City of Alexandria

Docket - Final

Saturday, June 15, 2013

City Council Public Hearing

Figure 1: Recommended Striping Plan dated April 25, 2013

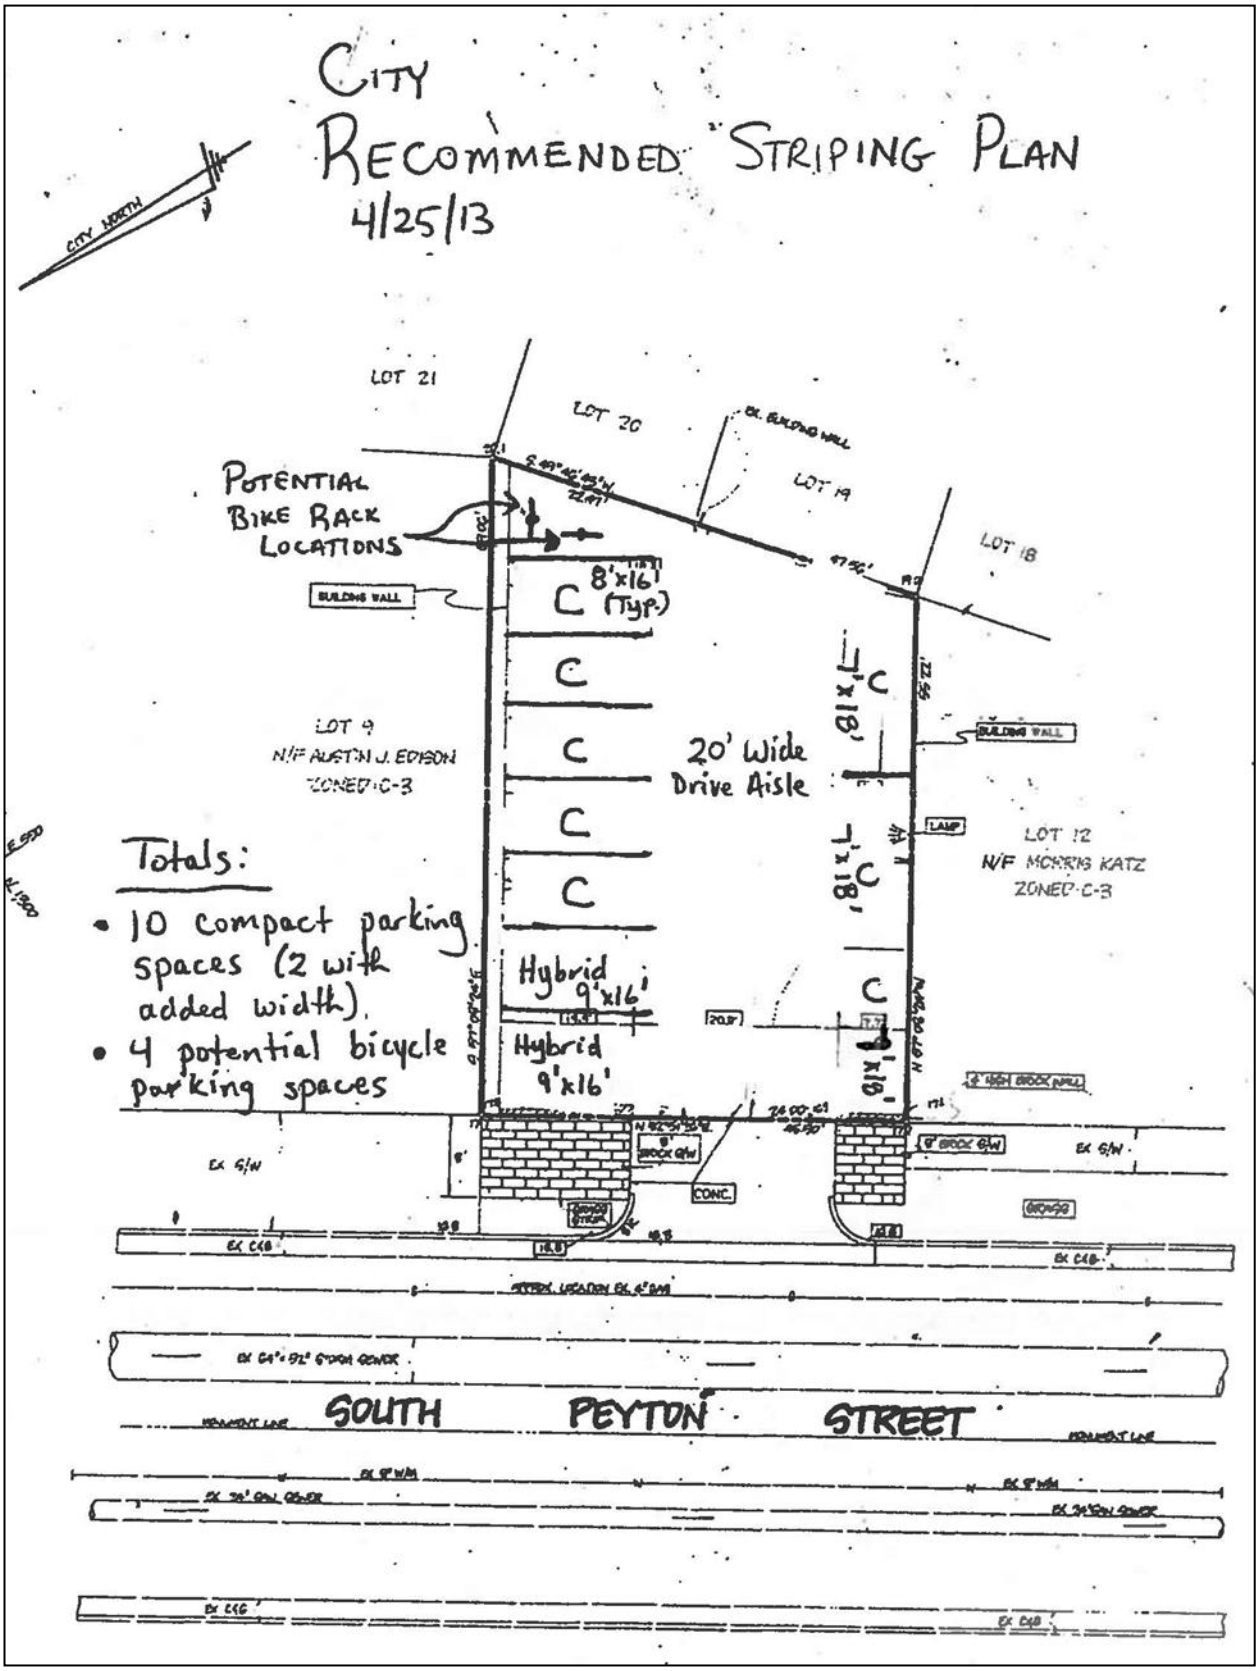
2. The proposed parking area is between two buildings and was approved in 1987 to accommodate only compact cars. Currently the parking area is not striped. T&ES recommends the attached striping plan (Figure 1), which would result in ten parking spaces that meet the City's zoning ordinance requirements for compact spaces. Two of the 90 degree spaces would have an extra 1 foot of width, resulting in a 9' wide x 16' long "hybrid" parking space. These hybrid parking spaces will help accommodate larger vehicles that may need to park on site. The parking lot design also accommodates the potential for installation of two bicycle racks in the northeast corner of the parking lot. (T&ES)
